**ADDENDUM NO. 1  
SHELBY COUNTY FIRING RANGE  
OCTOBER 5, 2012**

SHERIFF'S OFFICE RANGE OPERATIONS BUILDING  
AND FIRING RANGE  
SHELBY COUNTY GOVERNMENT  
MEMPHIS, TENNESSEE 38103

SHEET NO:  
**E2.2**

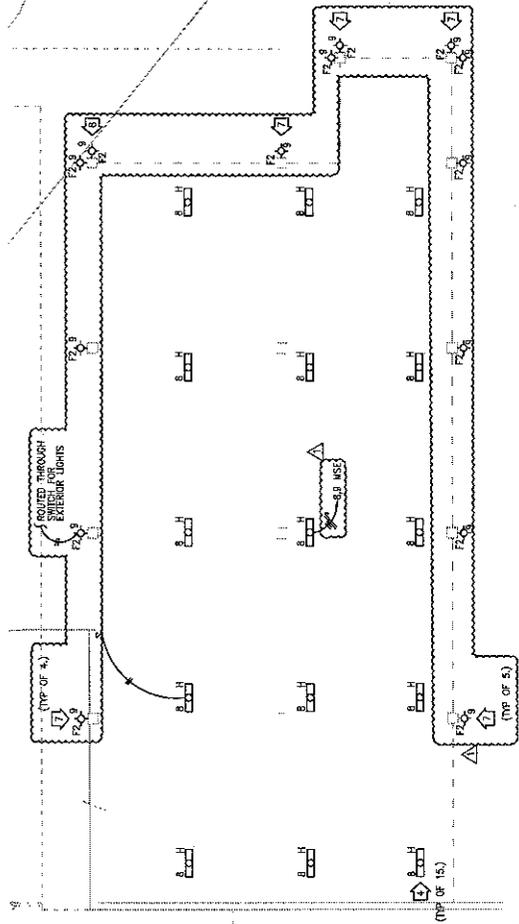
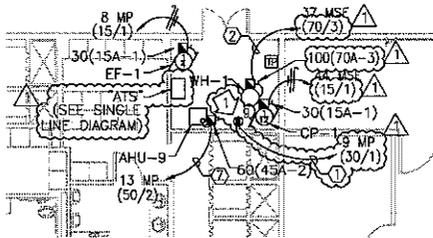
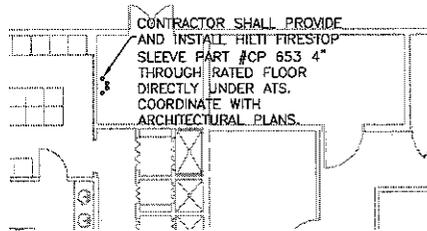
- ITEM NO. 10: DRAWINGS, SHEET E2.2: Remove and destroy this sheet and insert the attached revised Sheet E2.2 dated 10-3-12. The exterior lighting for the office building and the flag poles has been modified. The fixture changes have been revised in the fixture schedule and a lighting detail has been added.

E3.2A

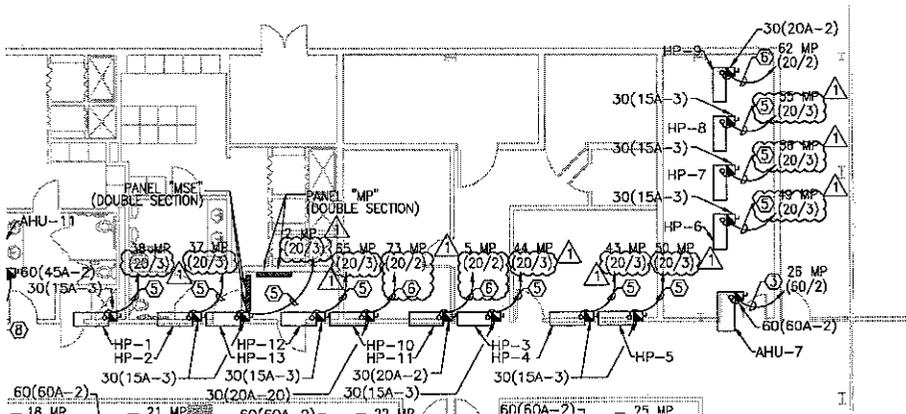
- ITEM NO. 11: DRAWINGS, SHEET E3.2: Insert attached Sketch E3.2A dated 10-3-12. The circuiting, along with the panel schedule, for some of the mechanical units has been revised.

Sections - ADDENDUM #1

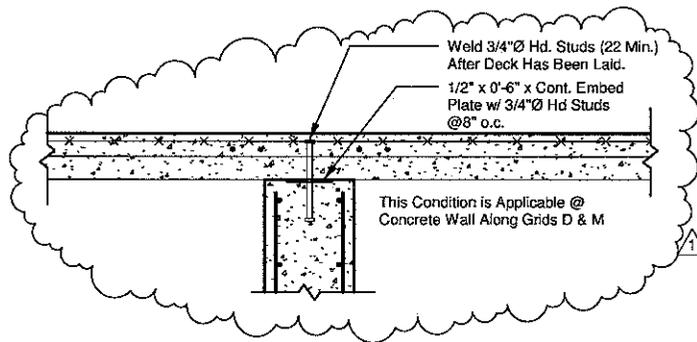
- ITEM NO. 3: DRAWINGS, SHEET S3.2: Insert attached Sketch S3.2A dated 10-3-12. Added sections 1 & 2 showing the connection of shear wall to floor diaphragm. This Detail to be applied at top of all concrete walls along grids 6, 12, D & M.

1 Section @ Top of Shear Wall  
3/4" = 1'-0"

2 Section @ Top of Shear Wall  
3/4" = 1'-0"

61902  
Job Number  
10-3-12  
Date  
EO.1A  
Sheet Number

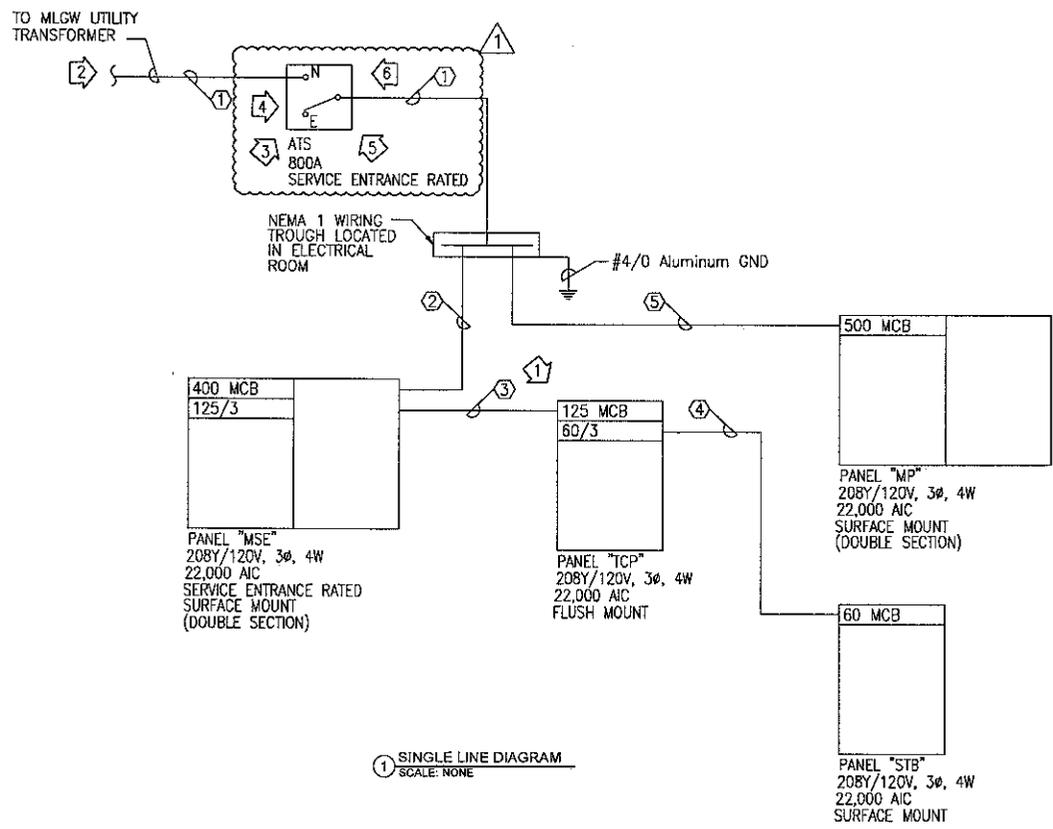
- ITEM NO. 4: DRAWINGS, SHEET E0.1: Insert attached Sketch E0.1A dated 10-3-12. The exterior lighting for the office building and the flag poles has been modified. The fixture changes have been revised in the fixture schedule and a lighting detail has been added.

E1.2A  
Sheet Number

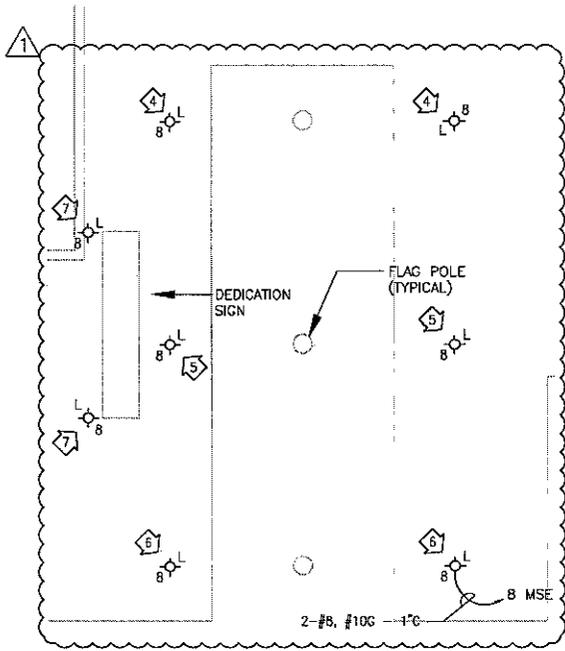
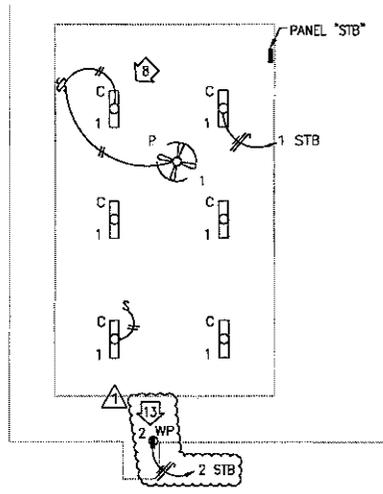
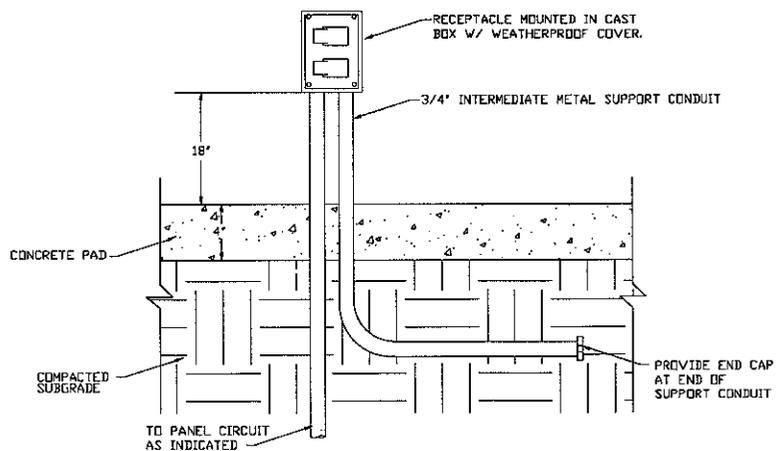
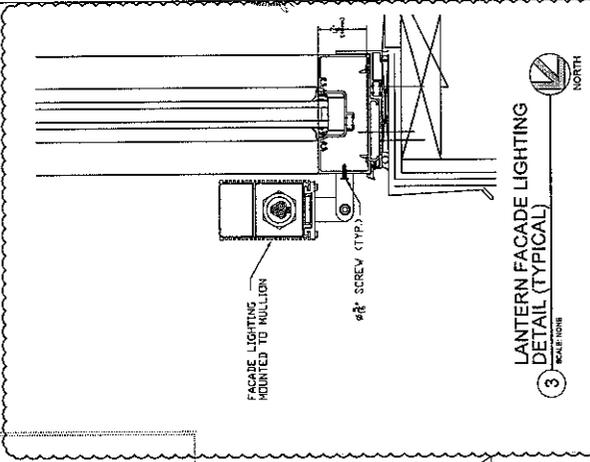
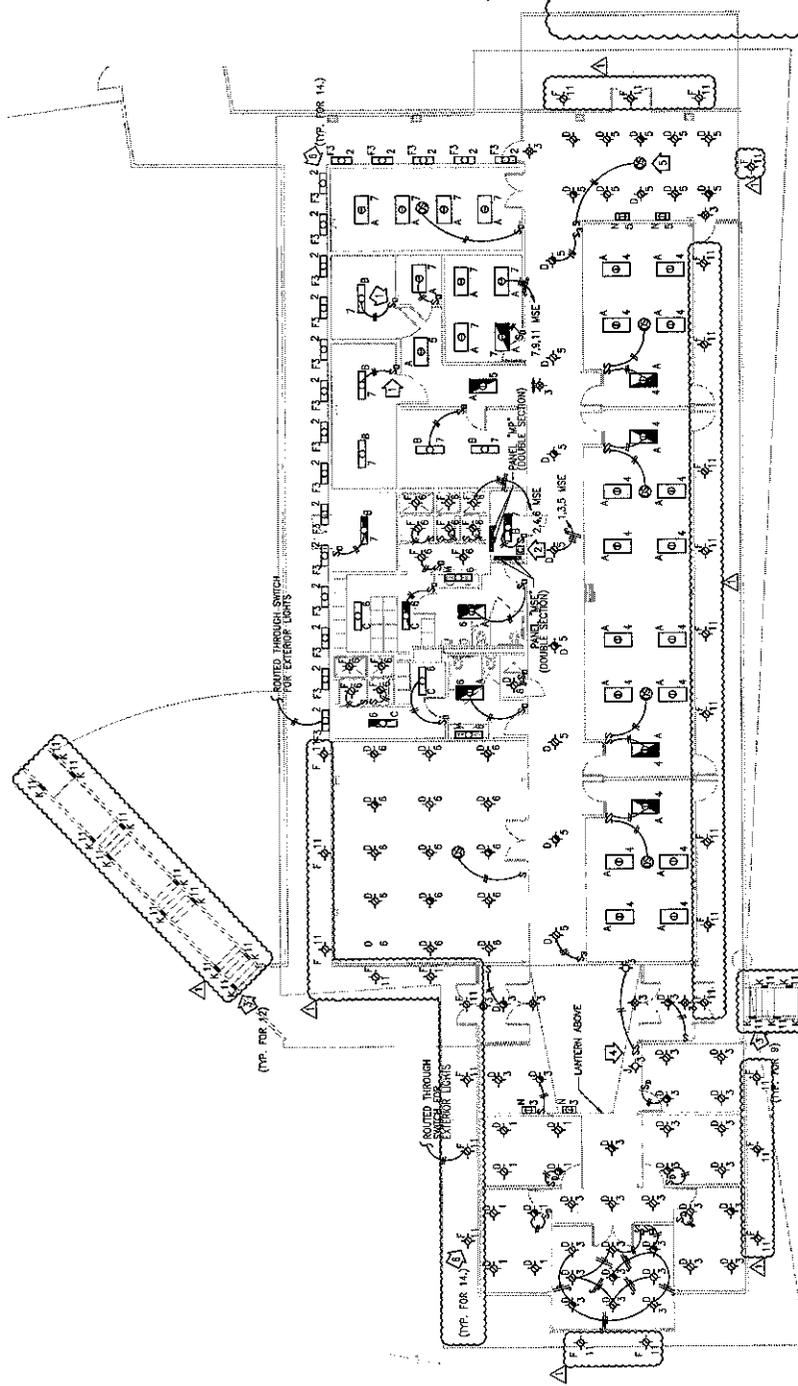
- ITEM NO. 7: DRAWINGS, SHEET E1.2: Insert attached Sketch E1.2A dated 10-3-12. The exterior lighting for the office building and the flag poles has been modified. The fixture changes have been revised in the fixture schedule and a lighting detail has been added.

- ITEM NO. 8: DRAWINGS, SHEET E1.2: Insert attached Sketch E1.2A dated 10-3-12. Pond Aerator - A power connection was added for the new pond aerator system. A new detail depicting the installation of this power connection was added as well.

POND AERATOR SHALL BE airBOOST-3 SHALLOW WATER AERATOR BY AERATION SUPPLY OR APPROVED EQUAL. AERATOR EQUIPMENT AND TUBING SHALL BE INSTALLED PER MANUFACTURERS SPECIFICATIONS. AERATOR SHALL BE SIZED FOR A 3 ACRE POND AT A MINIMUM.

13. OUTLET FOR POND AERATOR. OUTLET SHALL BE MOUNTED AS INDICATED IN DETAIL ON THIS SHEET. CONTRACTOR SHALL ALSO ROUTE (1) 1" PVC CONDUIT FROM CONTROL PANEL TO AERATOR LOCATION IN POND. CONDUIT SHALL BE ROUTED BELOW THE SLAB. COORDINATE EXACT LOCATION AND POWER REQUIREMENTS WITH CIVIL CONTRACTOR.

1 FLOOR PLAN - LIGHTING - ELECTRICAL  
 SCALE: 1/4" = 1'-0"

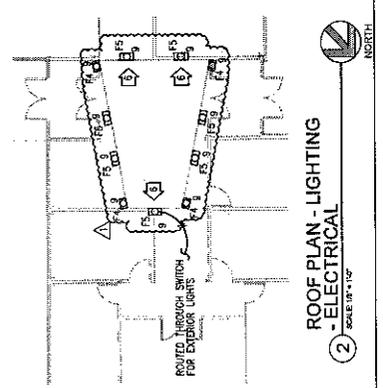
- ITEM NO. 9: DRAWINGS, SHEET E2.1: Remove and destroy this sheet and insert the attached revised Sheet E2.1 dated 10-3-12. The exterior lighting for the office building and the flag poles has been modified. The fixture changes have been revised in the fixture schedule and a lighting detail has been added.
